Illinois Tollway Base Sheet Revisions

Section M	Base Sheet Drawings	
	Drawing	**Modification Summary** **Effective: 03-1-2021**
	Roadway (RDY)-Series 400	
	M-RDY-400	**ROADWAY TYPICAL SECTIONS GROUP A**
		Inside shoulder cross slope reviesed from 4% to 3% for normal crown typicals.
		Subgrade layer added to all typical sections.
		Roadway Design Criteria Manual Section 2.4.9 referenced for all Rollover (Max.) areas.
		Note added to reference the Longitudinal Joint Sealant sheet M-RDY-415.
	M-RDY-401	**ROADWAY TYPICAL SECTIONS GROUP B**
		Subgrade layer added to all typical sections.
	M-RDY-404	**ROADWAY TYPICAL SECTIONS GROUP E**
		Revised R.O.W. dimension from 5' (MIN.) to 3' (MIN.).
		Revised a dimension leader.
	M-RDY-406	**ROADWAY TYPICAL SECTIONS GROUP G**
		Clarified flat area behind NAW wall measured from the back of the post
	M-RDY-407	**EARTHWORK SCHEDULE, SHEET 1,2 AND 3**
		Revised all earthwork tables.
		Added Non Special Waste Disposal Type 1 table.

APPROACH SLAB, MAINLINE

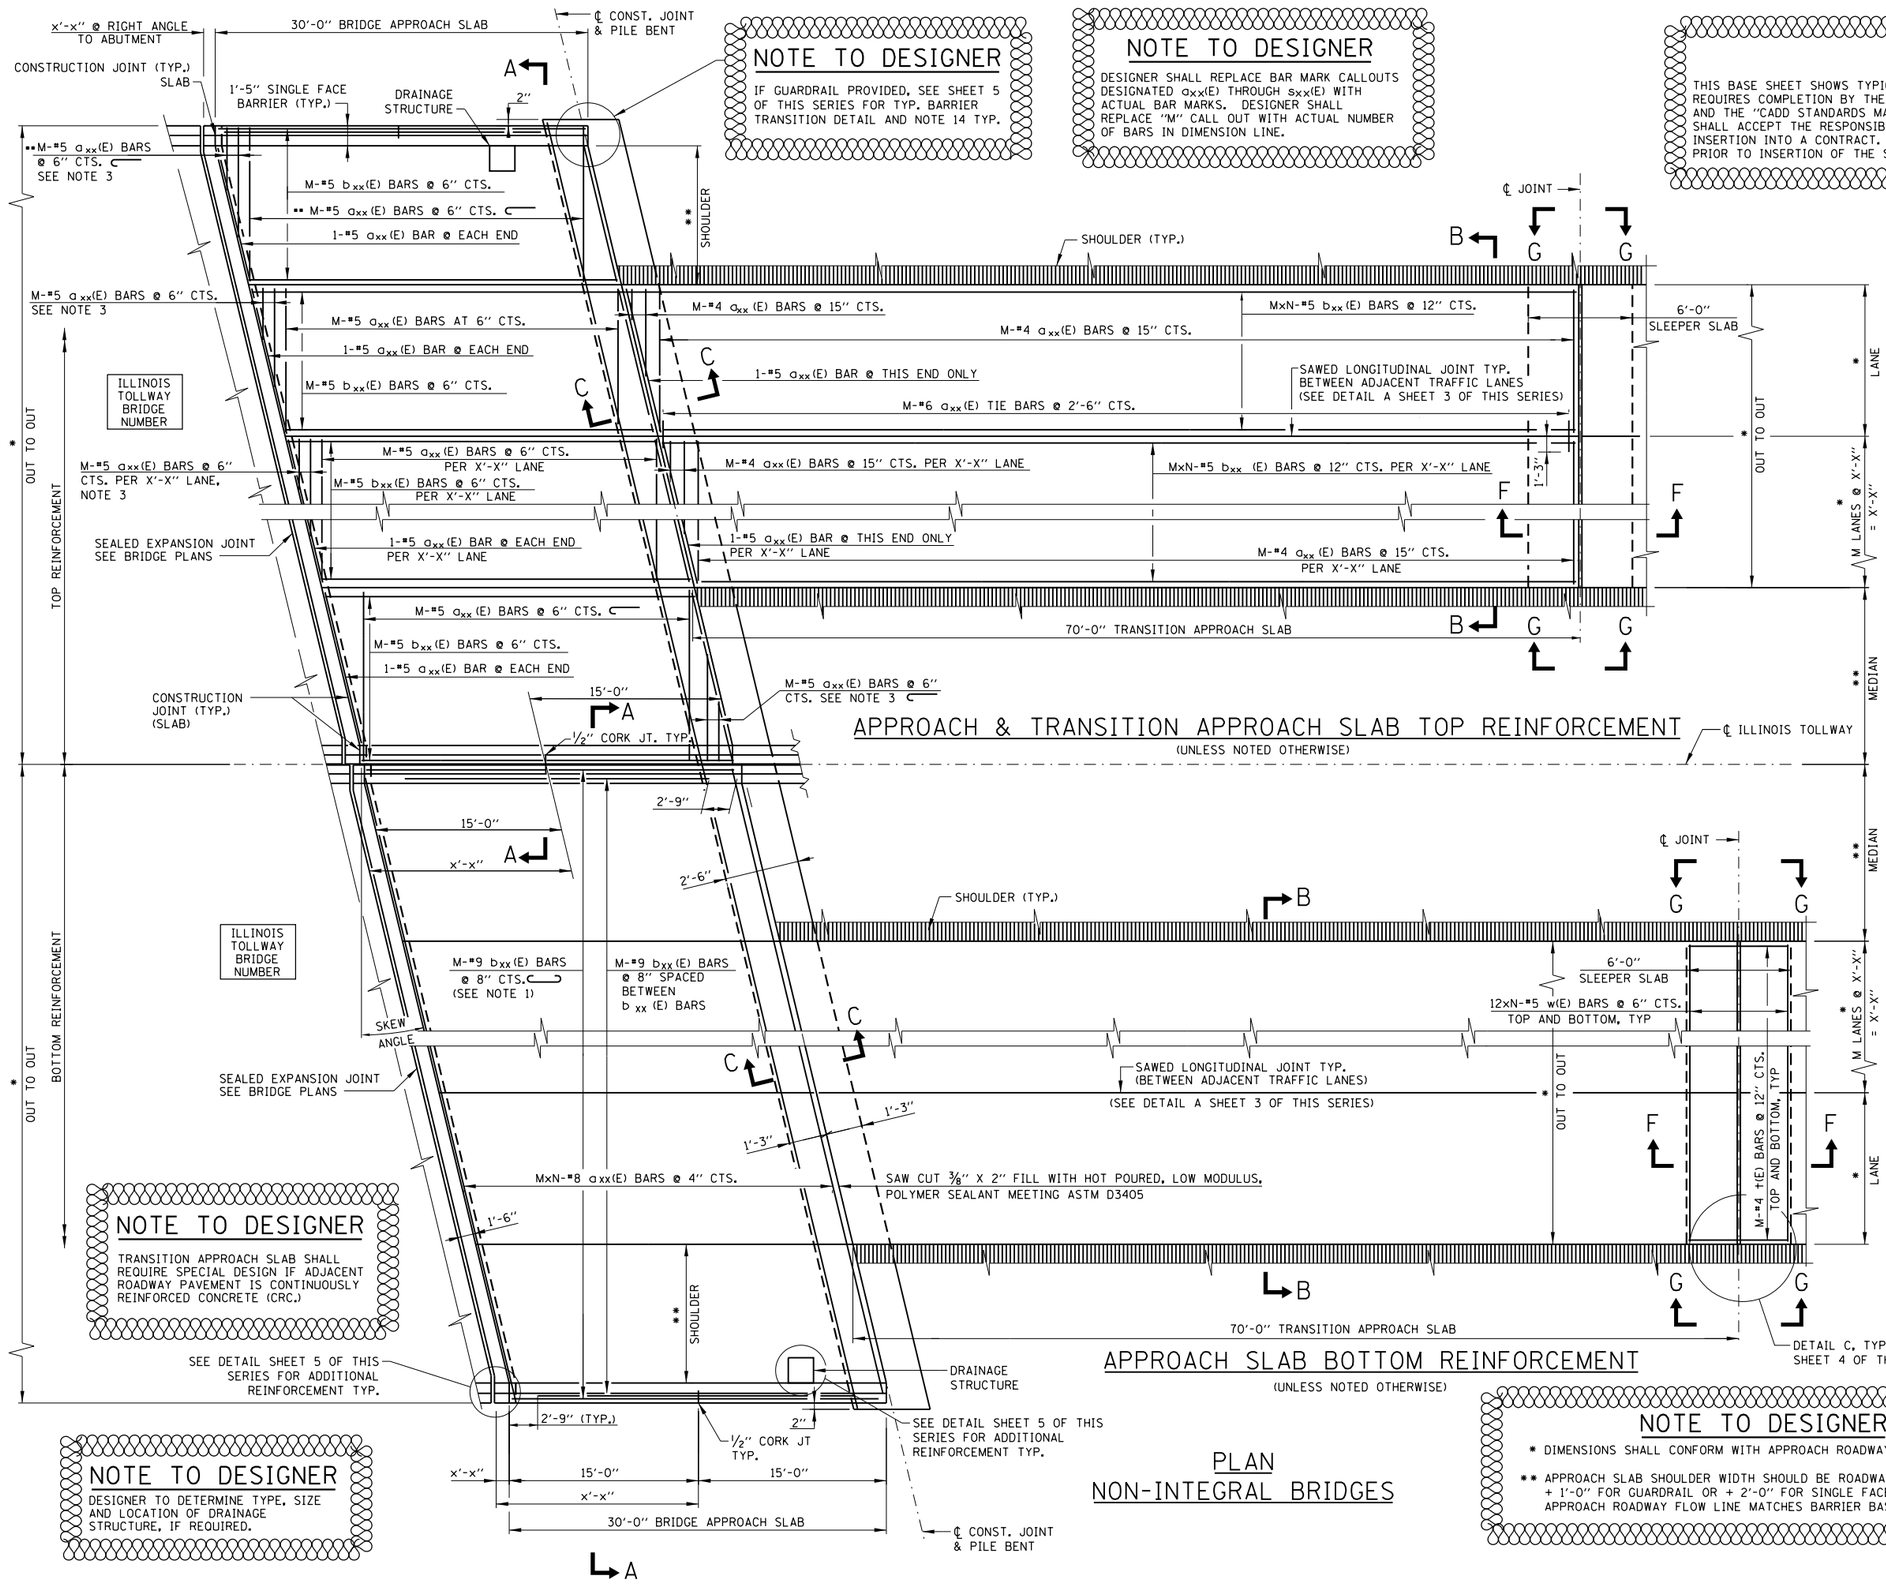
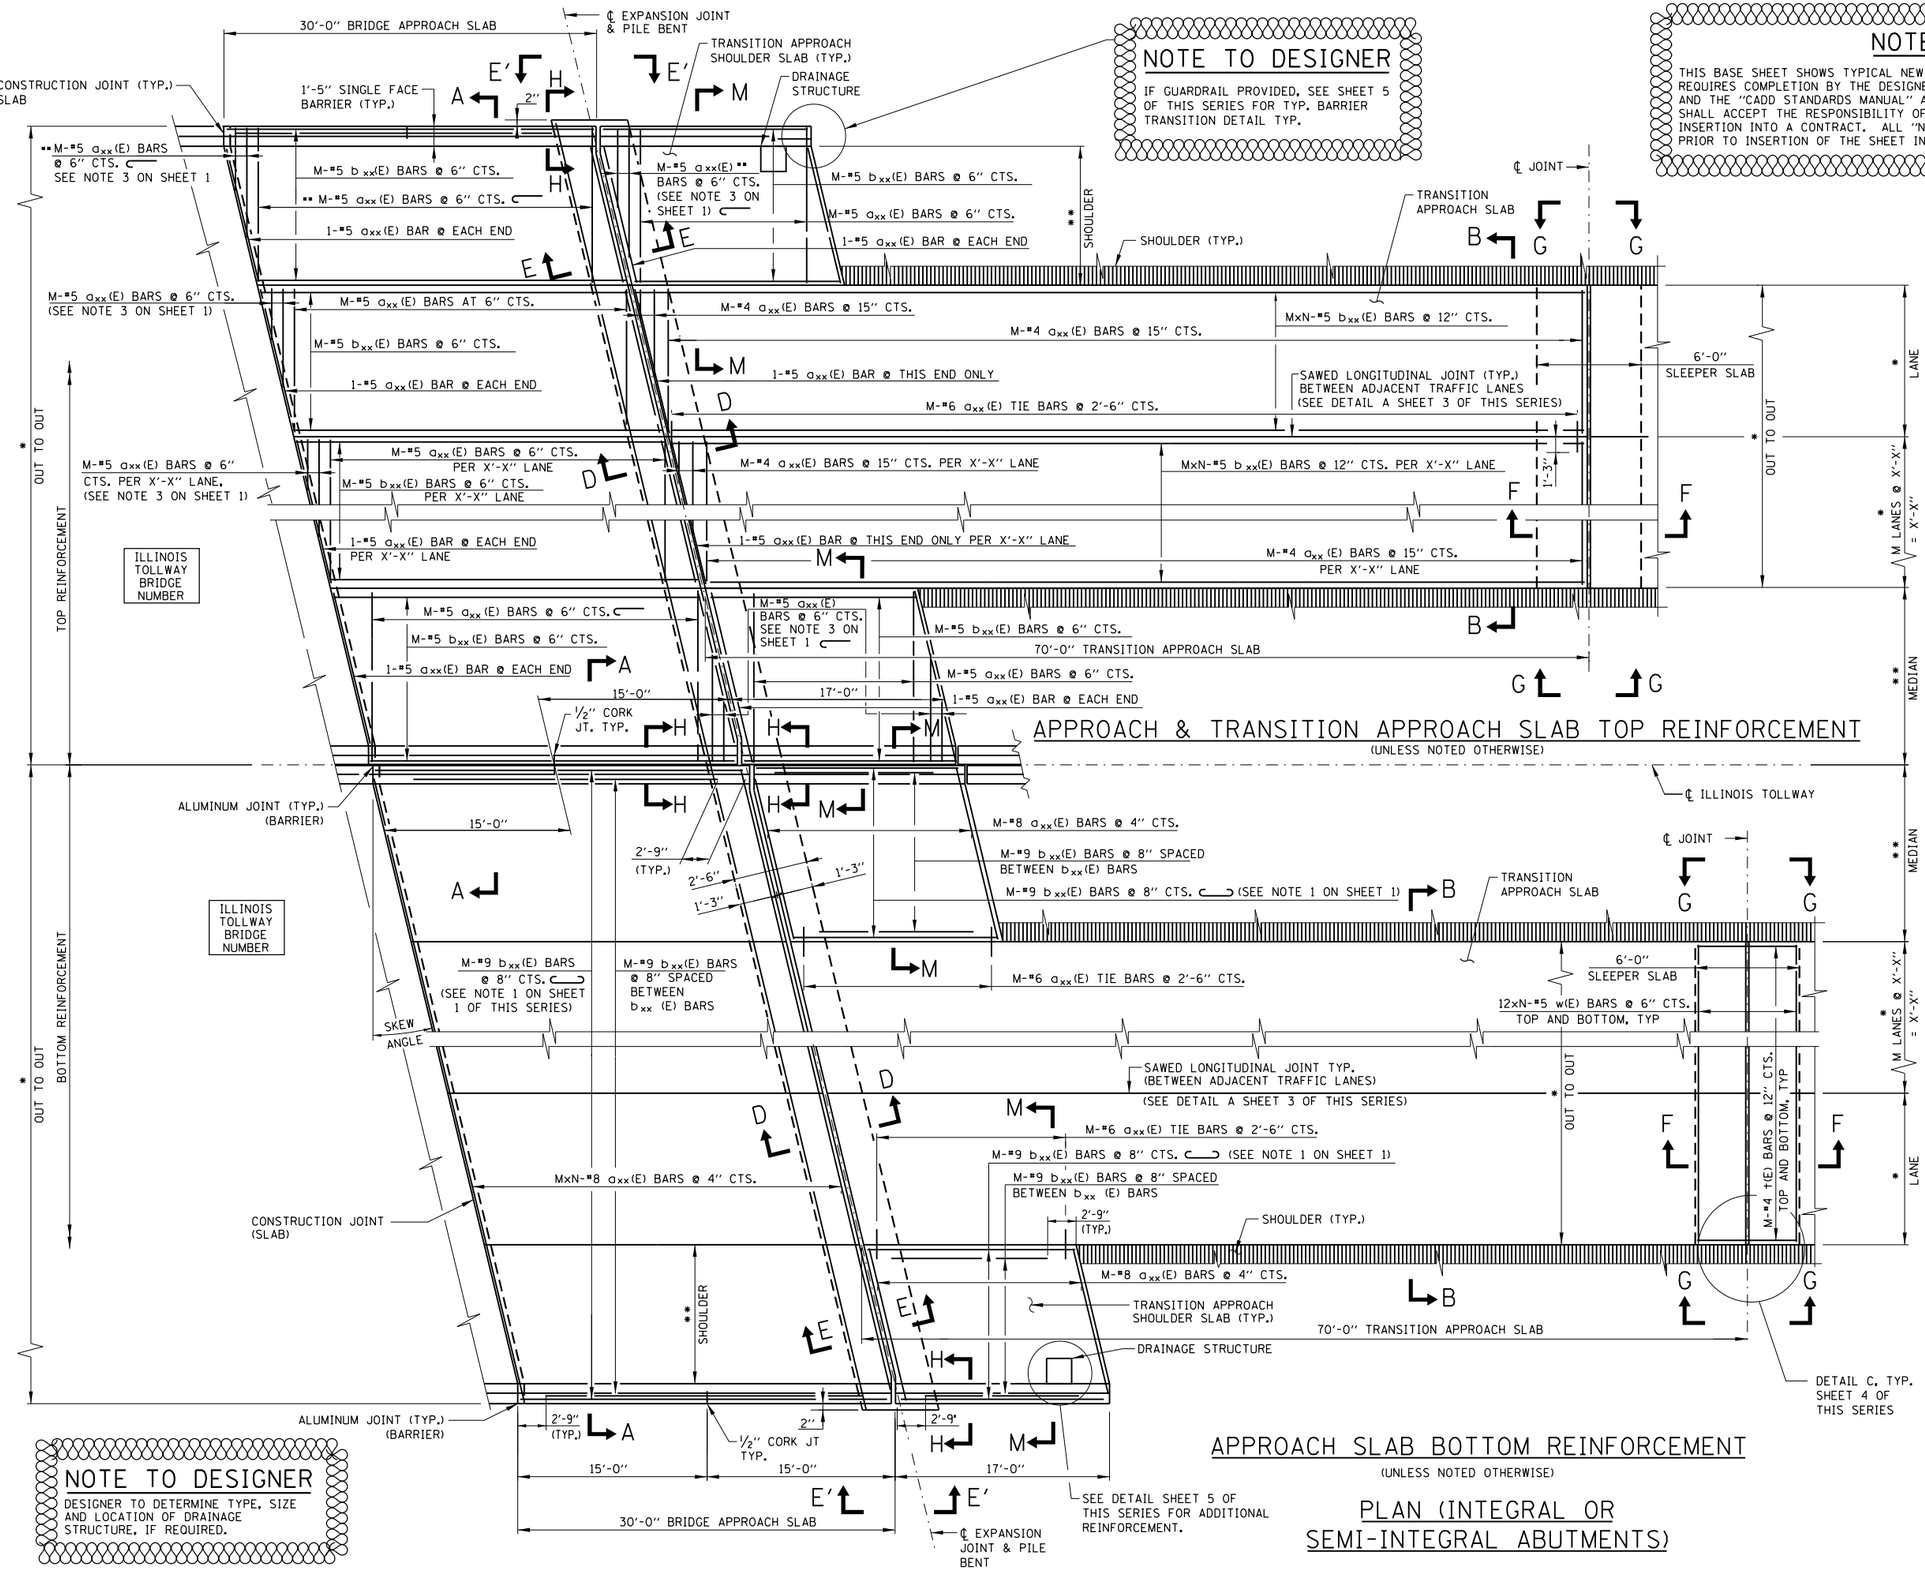
M-RDY-408	**APPROACH SLAB, MAINLINE, SHEETS 1, 2, 3, AND 5**
		Revised top transverse bars above shoulder to be hooked bar.
		Added a designer note to replace the top transverse hooked bars when the height of the barrier is 72".
	M-RDY-409	**APPROACH SLAB, RAMP, SHEETS 1, 2, 3, AND 5**
		Revised top transverse bars above shoulder to be hooked bar.
	M-RDY-410	**PRECAST APPROACH SLAB W/CIP TRANSITION SLAB, SHEET 1**
		Revised top transverse bars above shoulder to be hooked bar.
		Added a designer note to replace the top transverse hooked bars when the height of the barrier is 72".
		Revised top transverse bars spacing to 6".
		Revised bottom transverse bars to #8 @ 5".
		Revised bottom longitudinal bars spacing to 9" from 8".
	M-RDY-410	**PRECAST APPROACH SLAB W/CIP TRANSITION SLAB, SHEET 2**
		Added a designer note to provide requirements for precast panel width.
	M-RDY-410	**PRECAST APPROACH SLAB W/CIP TRANSITION SLAB, SHEET 3**

SECTION M-M
CIP TRANSITION APPROACH SHOULDER SLAB

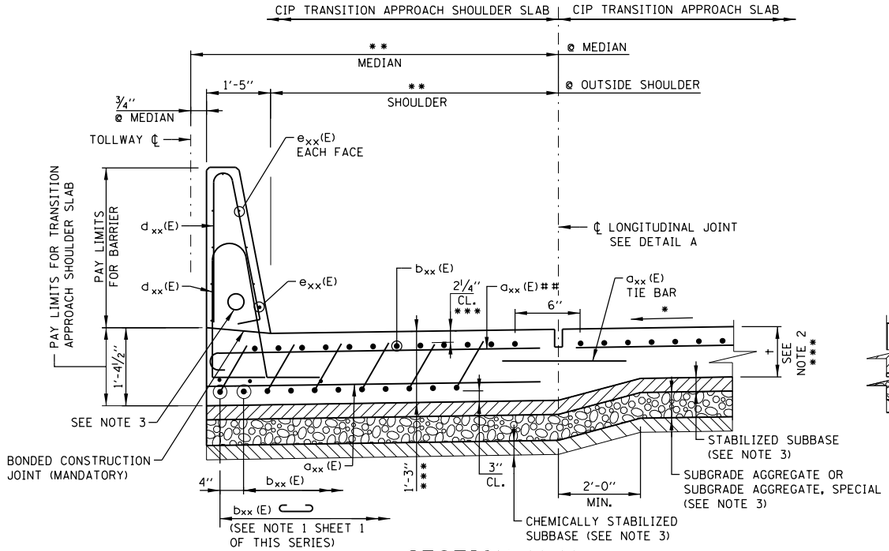
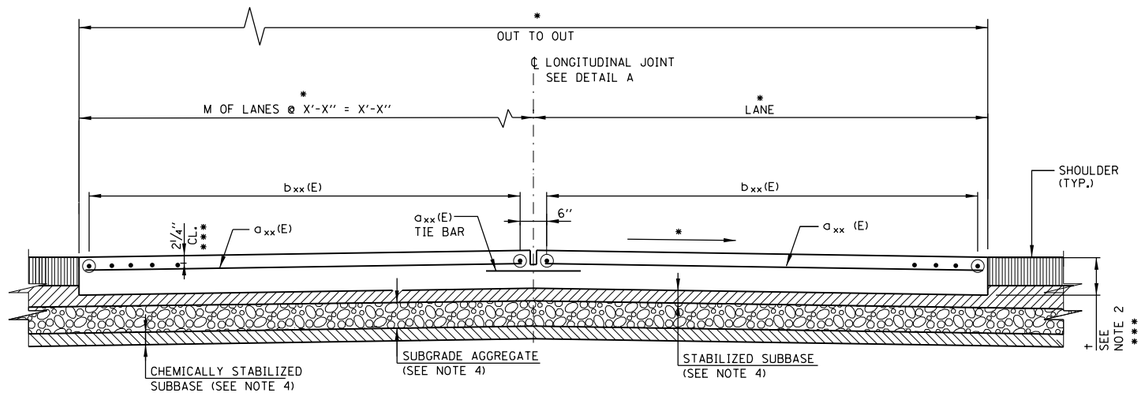
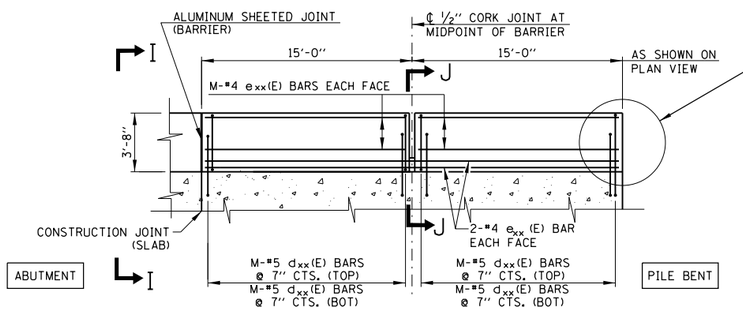
Revised top transverse bars above shoulder to be hooked bar.
		Added a designer note to replace the top transverse hooked bars when the height of the barrier is 72".
	M-RDY-410	**PRECAST APPROACH SLAB W/CIP TRANSITION SLAB, SHEET 5**
		Revised top transverse bars above shoulder to be hooked bar.
		Added a designer note to replace the top transverse hooked bars when the height of the barrier is 72".
	M-RDY-410	**PRECAST APPROACH SLAB W/CIP TRANSITION SLAB, SHEET 7**
		Added hooked bar bending details .
		Added a designer note to update the barrier bars based on the barrier type.
	M-RDY-411	**EMERGENCY TURNAROUND, MEDIAN WIDTH < 35FT, SHEET 4**
		Revised inside shoulder cross slope to 3% for Sections F-F, G-G, and H-H
	M-RDY-412	**ROADWAY SUBGRADE SLOPES MEDIAN BARRIER**
		Roadway Design Criteria Manual Section 2.4.9 referenced for all Rollover (Max.) areas.
		Revised inside shoulder cross slope from 4% to 3% for the normal crown section.

USE #7 axx(E) HOOKED BARS AT 5" SPACING FOR TOP TRANSVERSE BARS OVER SHOULDER WHEN THE BARRIER HEIGHT IS 72".

TYPICAL LJS
(FIGURES 1 & 2)

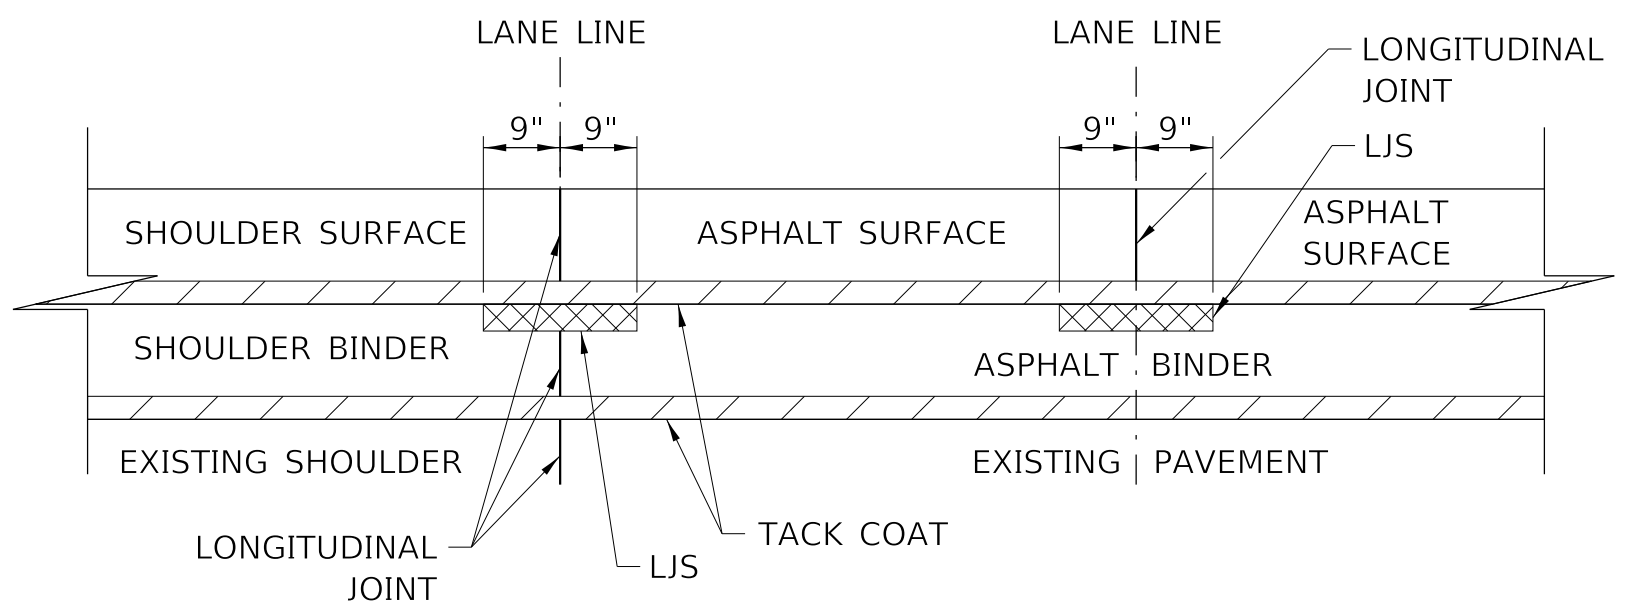
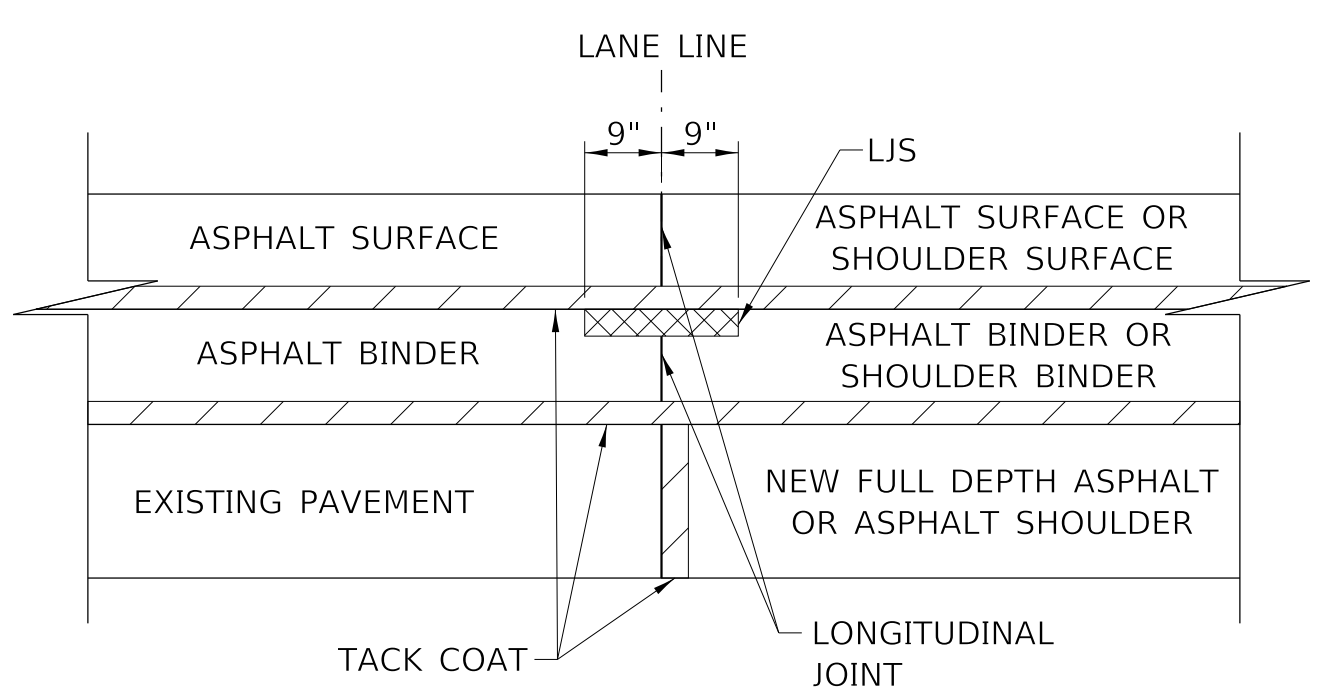
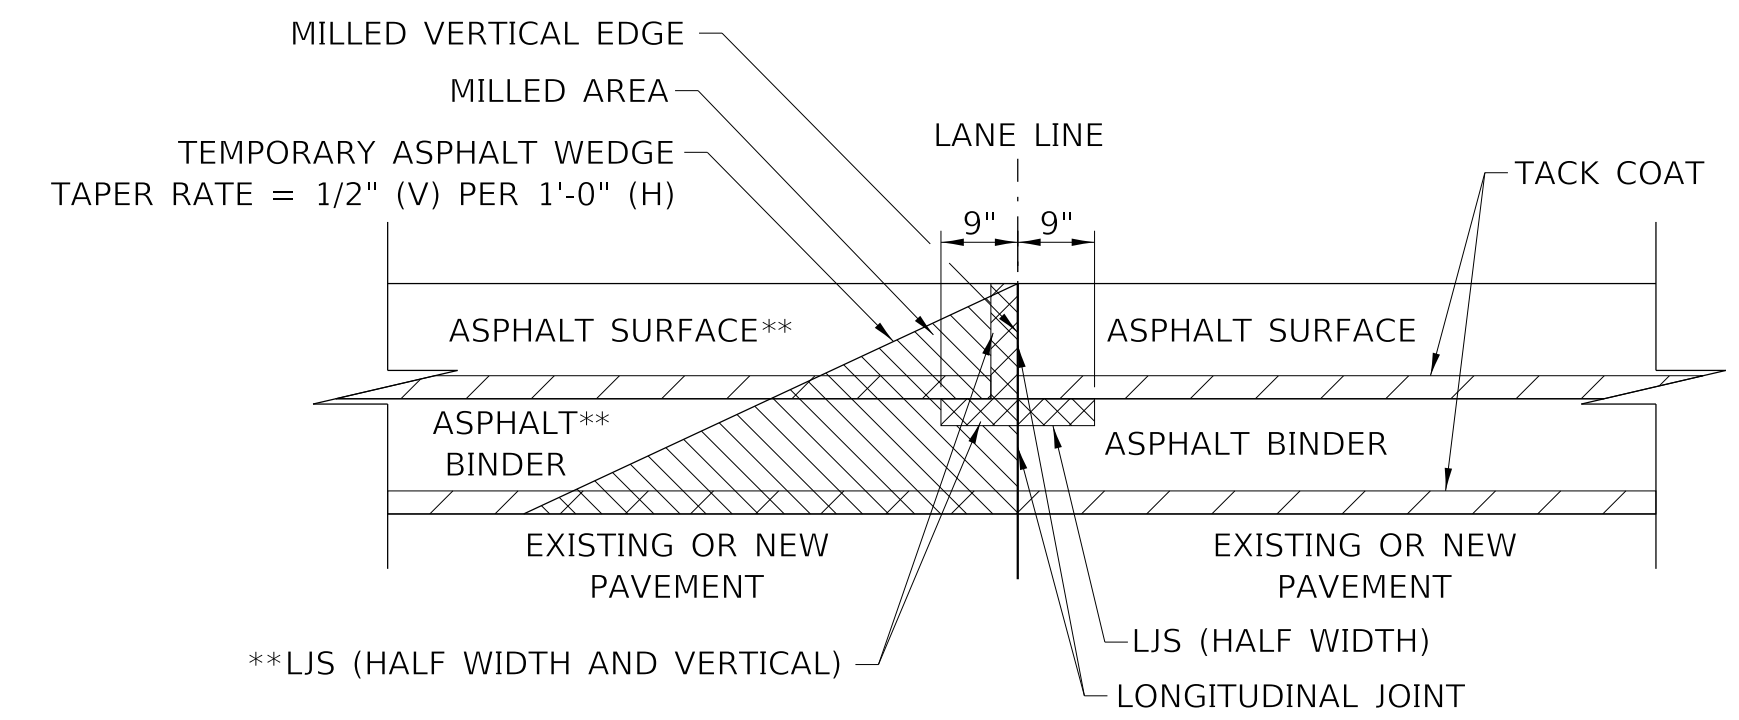
M-RDY-415	**LONGITUDINAL JOINT SEALANT**
		Added detail for Longitudinal Joint Sealant locations and Quantities.
